## **INQUIRY INTO BARANGAROO SIGHT LINES**

## SUBMISSION TO THE INQUIRY INTO BARANGAROO SITE LINES

Submission on Proposed Amendment to  
Concept Plan MP 06\_0162

# Barangaroo Central

*Figure 7: Applicant's misrepresentative view impact assessment of the approved Concept built-form viewed from the  
Langham Hotel roof level (Source: AECOM View Impact Assessment December 2021)*

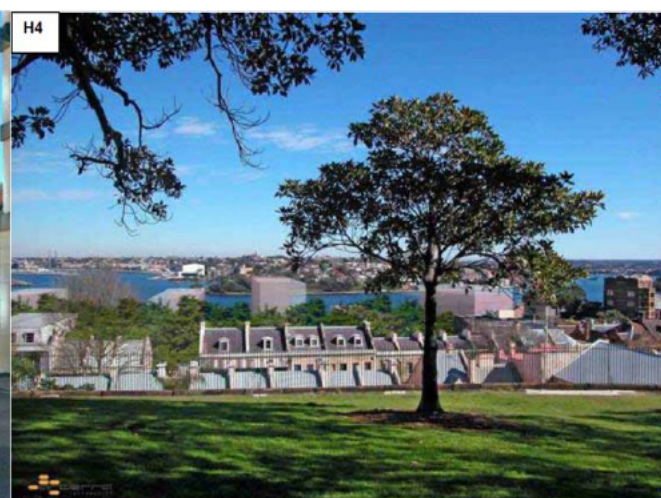
Having regard to the key methodological error in the MOD 9 application documents, the photomontages provided by the developer as they relate to the approved Concept Plan are erroneous at best, and likely highly misleading. We have obtained photomontages prepared on behalf of the Langham Hotel by Digital Line to illustrate the approved building envelope of the Barangaroo Central site as viewed from neighbouring sites and based on the approved

They make clear the difference between the respective “base cases” from which to assess the impact of MOD 9 and show graphically how dramatically the MOD 9 application has overstated the extent of the current approved development.

Figure 13: Existing Height of Buildings

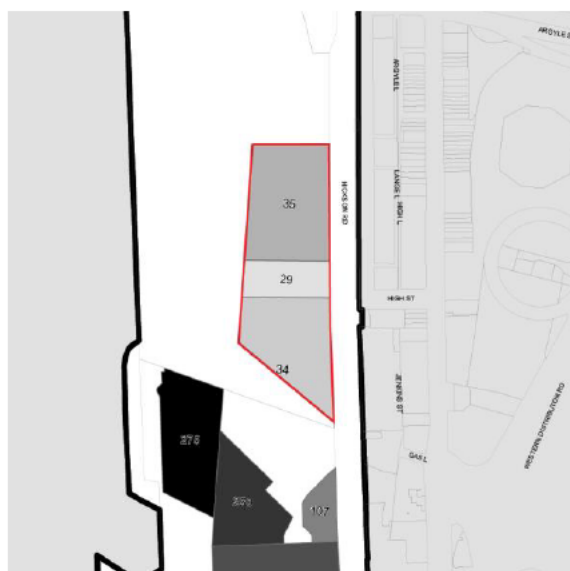
A notable feature of the proposed modification is that there are very detailed height limits proposed at different areas of the site. This contrasts with the existing Concept Plan which has only one height limit for each block. The developer is clearly seeking to lock in detailed height limits in the MOD 9 application in a way that was not done for the original Concept Plan application.

Figure 18: Proposed Building Envelope, Axonometric View

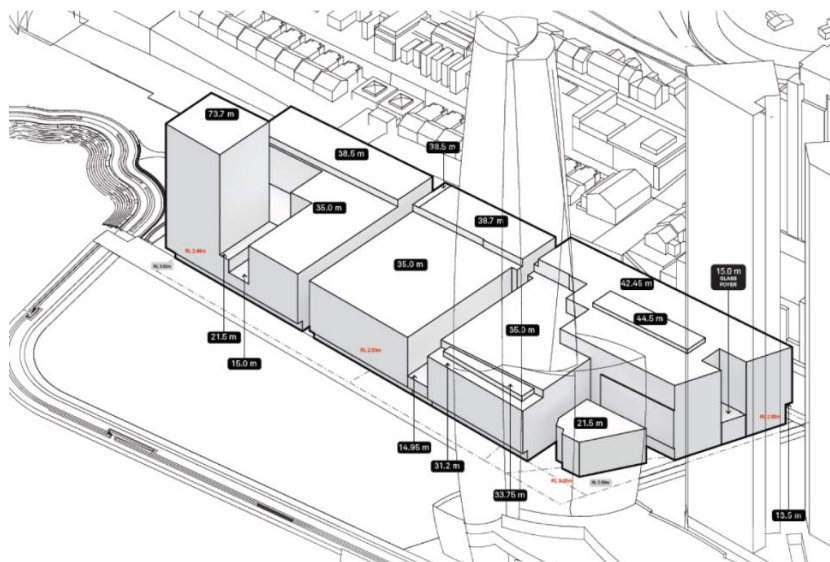
The proposed building envelope would significantly alter the character of the surrounding area, imposing sizeable bulk and scale upon a context that currently consists of low density, heritage significant urban development leading to wide public spaces, and open harbour and foreshore views.

*Figure 21: Proposed Building Envelope. Level 2 of The Langham Hotel, facing west (prepared by Digital Line).*

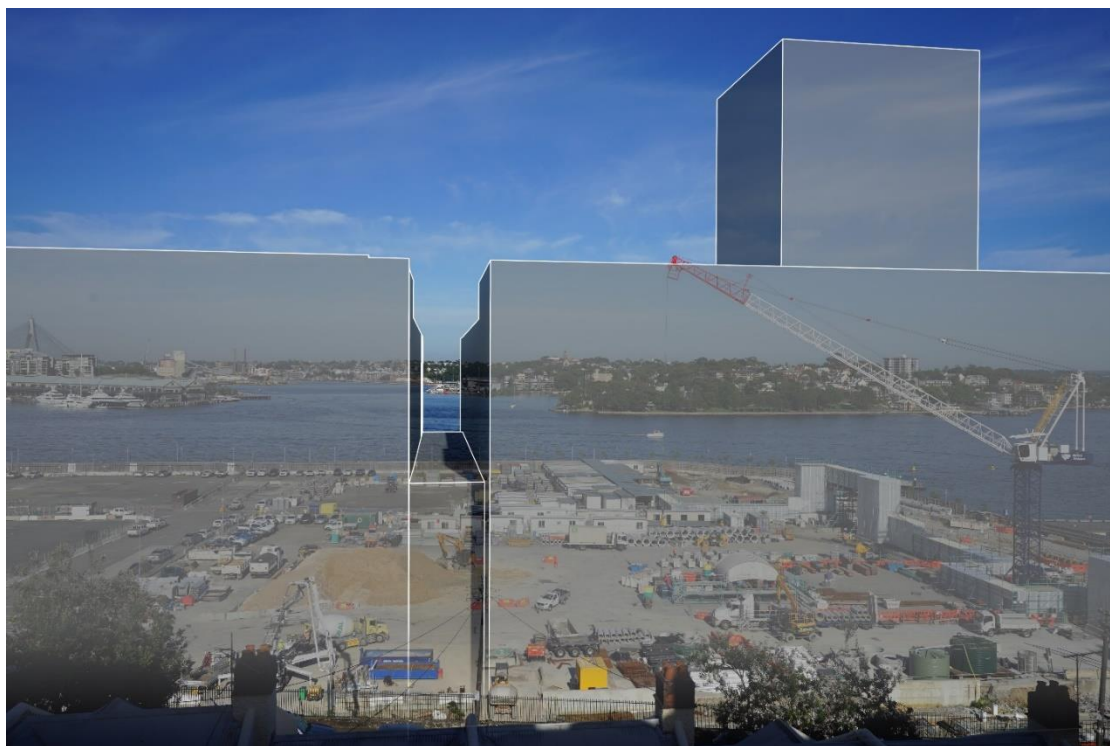
The photomontages provided in Figure 20 and Figure 21 illustrate the relative impact the MOD 9 proposed building envelope would have upon characteristic views from the Langham Hotel to the harbour.

Figure 23: View from Observatory Hill of approved Concept building envelope (Source: City Plan Heritage Impact Assessment Attachment B (September 2006), prepared by Arterra Interactive)

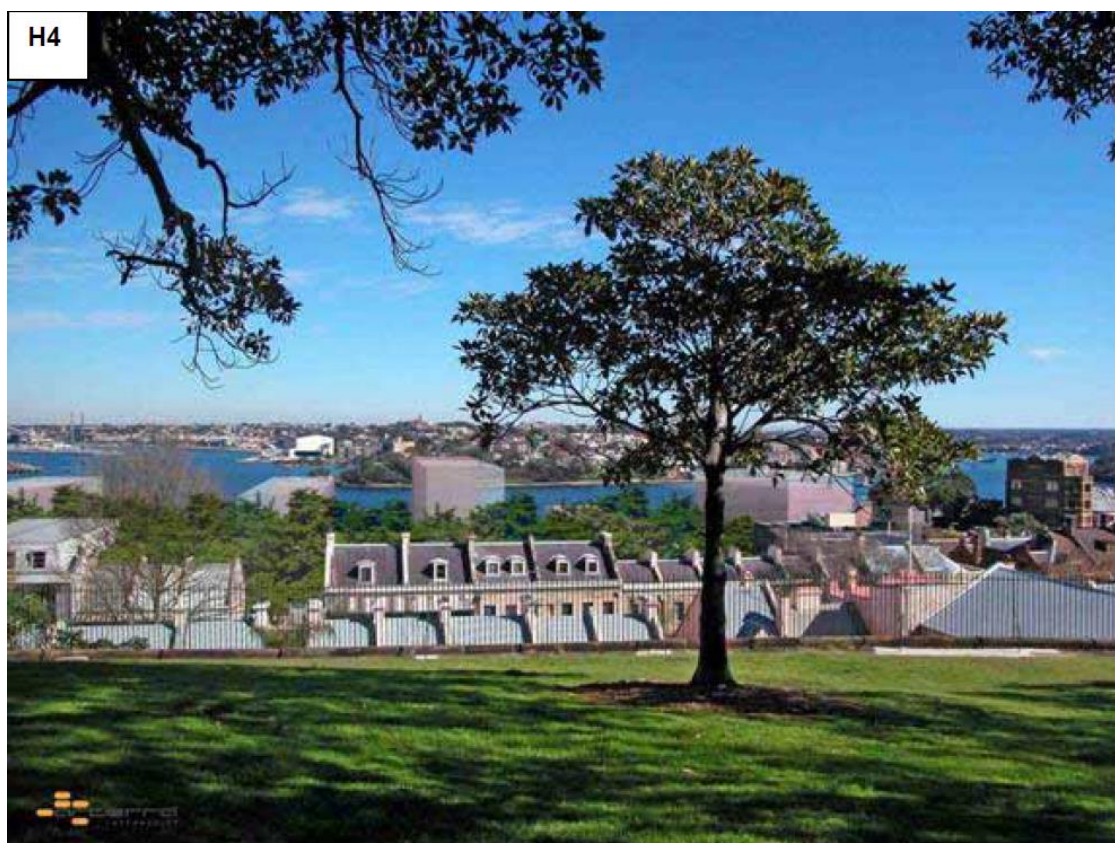
As noted above, the key methodological error is that the modification application erroneously represents the form of the approved building envelope at Barangaroo Central by presenting a uniform maximum permissible building height and ignoring the wide range of design principles, design requirements and development controls that are given in the approved Concept Plan (Section 13.0 of the *EDH State Significant Site Proposal and Concept Plan*). These guiding principles and development controls articulate the building envelope of Blocks 5, 6 and 7 in contrast to the uniform overall maximum building height given in the Eastern Harbour SEPP. The design principles and controls did not envisage that the building envelope would maximise the permissible heights across the entire floorplate and provided for wide laneways as outlined in Appendix A of this submission. For example, the design controls envisaged that only 15% of Block 6 envelope would be up to RL29 and only 20% of the Block 5 envelope would be up to RL29. The design controls for Block 7 envisaged a variable and articulated height to allow view corridors through the building rising from RL9.7 to a maximum of RL35.

The anticipated rise and fall of the approved building envelope is clearly shown in the view impact assessment undertaken as part of the Heritage Report prepared for the original concept approval.

*Figure 26: Applicants misrepresentation of the Concept Plan approved form, viewed from Kent St, along High St to Hickson St (Source: AECOM December 2021)*

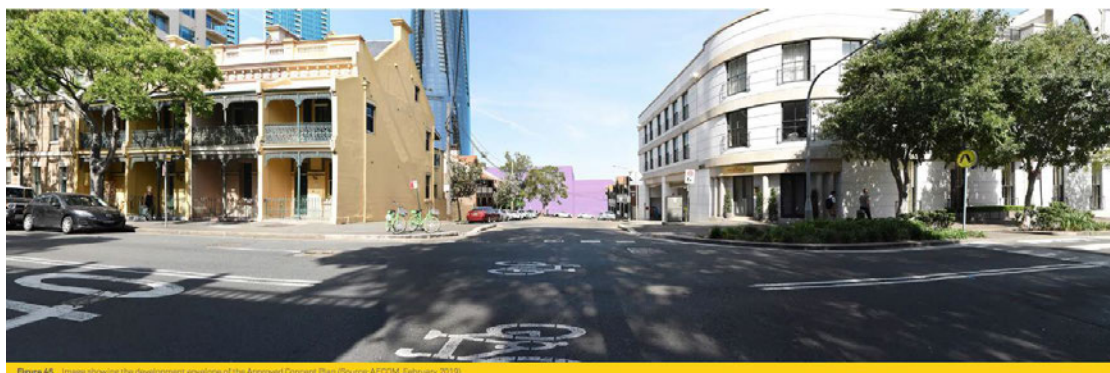
The approved envelope assessed as part of the Applicant's view impact assessment does not take into account these Design Principles and Controls when demonstrating the approved built form to assess the impact of the proposed MOD 9 built form.

*Figure 28: Indicative Building Envelope at Barangaroo Central, facing west, as detailed in the approved Concept Plan (prepared by Digital Line).*

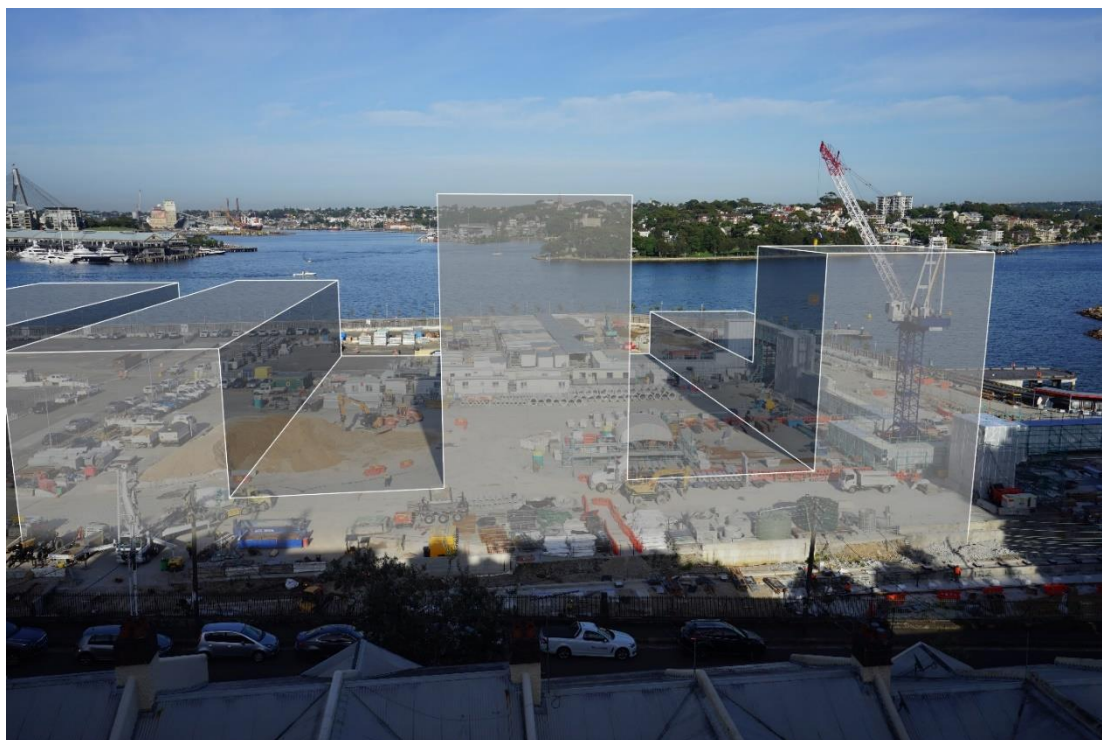
Figure 28 and Figure 29 below detail the indicative building envelope at Barangaroo Central as detailed by the approved Concept Plan and as misrepresented by the MOD 9 application.

*Figure 32: View impact assessment of the approved concept plan, considering the Design Principles and Controls provided by the Concept Plan October 2006 (prepared by Digital Line)*

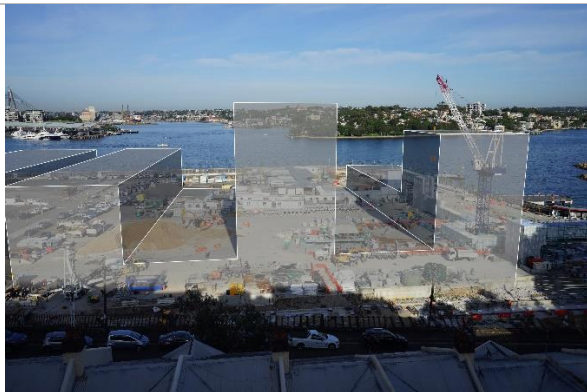
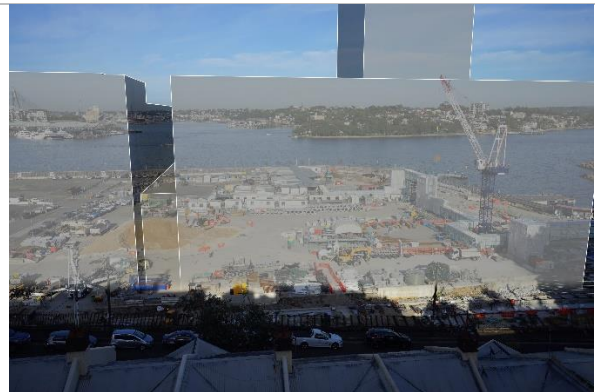
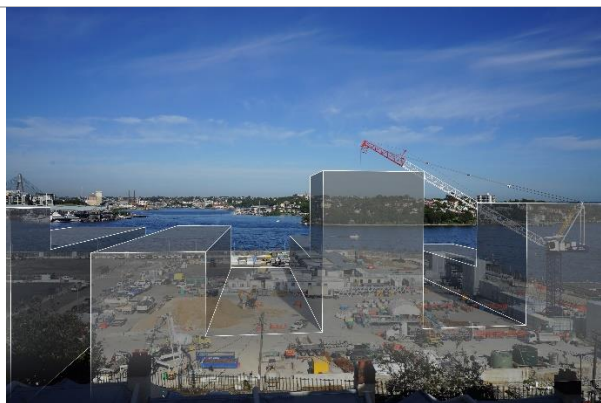
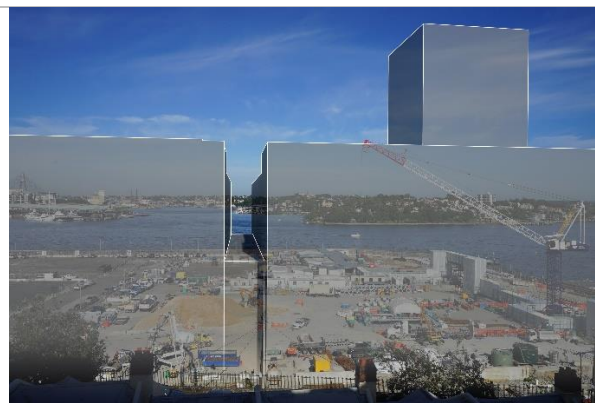
- a. The proposed building envelope significantly exceeds the modulated heights given in the Concept Plan and removes all view corridors to the harbour and foreshores. When compared to the approved Concept Plan accurately, the result would be a significant decline in the amenity of The Langham Hotel and its surrounds and the quality of the tourism offering that The Langham provides.

- d. The *View and Visual Impact Assessment* submitted with the MOD 9 application inadequately and incorrectly addresses view loss impacts. As explained in Section 5.4.2 of this Submission, the *View and Visual Impact Assessment* provides an inaccurate depiction of the 'currently approved' building envelope which ignores the design principles and guidelines in the Concept Plan. As such, the comparative exercise contained within the *View and Visual Impact Assessment* is erroneous and should not be used in decision-making.

Figure 38: Applicant's urban design analysis of the existing approved Concept Plan and proposed built form (Source: Urban Design Report prepared by Hassell December 2021)

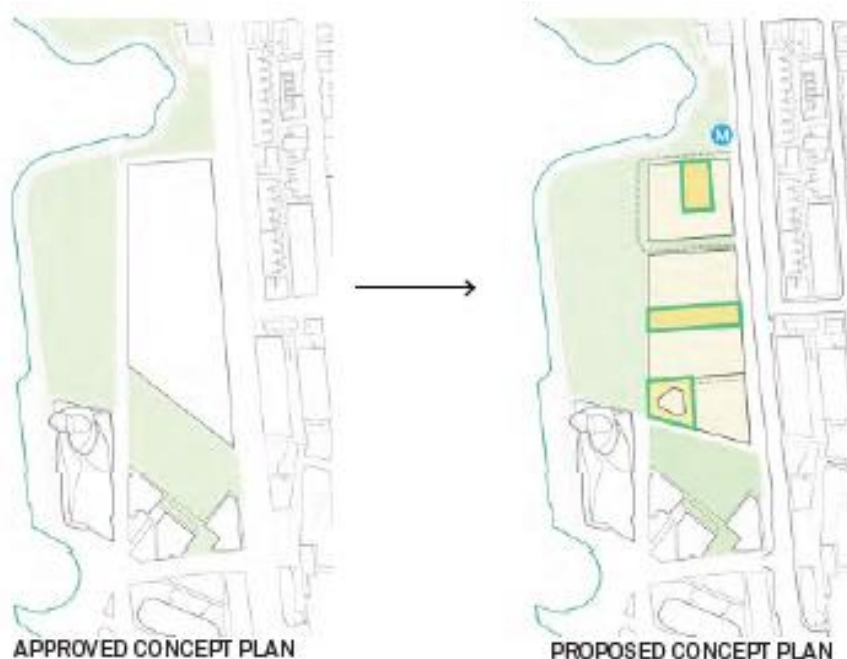
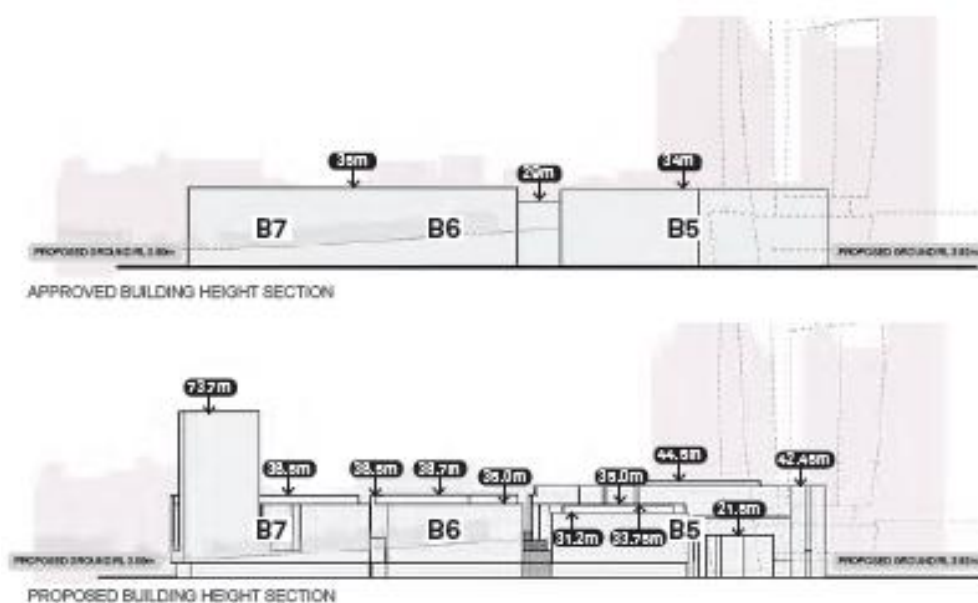
The MOD 9 application fails to take into consideration the design principles, design requirements and development controls of the approved Concept Plan and proposes a building envelope that demonstrates poor urban design and adversely impacts the surrounding context.

The MOD 9 proposal exhibits an overall disregard for the carefully considered built form controls that have been established to ensure development at Barangaroo Central provides urban design outcomes appropriate for the setting. The applicant's Urban Design Report (Hassell December 2021) erroneously states that there are currently no design principles or controls applicable to the Central Barangaroo site.

Figure 41: Concept Plan illustration of the height tapering envisaged within the Barangaroo precinct (Source: Part B Concept Plan prepared by EDG October 2006)

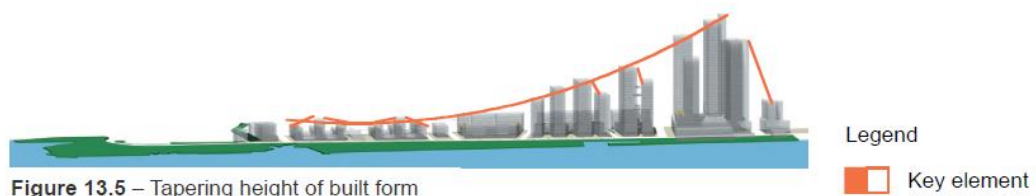
- c. Furthermore, this northernmost location is in direct conflict with a number of design principles and commitments detailed throughout the approved Concept Plan, which requires development at Barangaroo to “reduce towards the northern end of the site, where built form meets the Headland Park”. The approved Concept Plan envisages a tapering in height from south to north Barangaroo as shown in Figure 41. The northernmost location exacerbates concerns of overshadowing and adversely impacts public amenity and views.
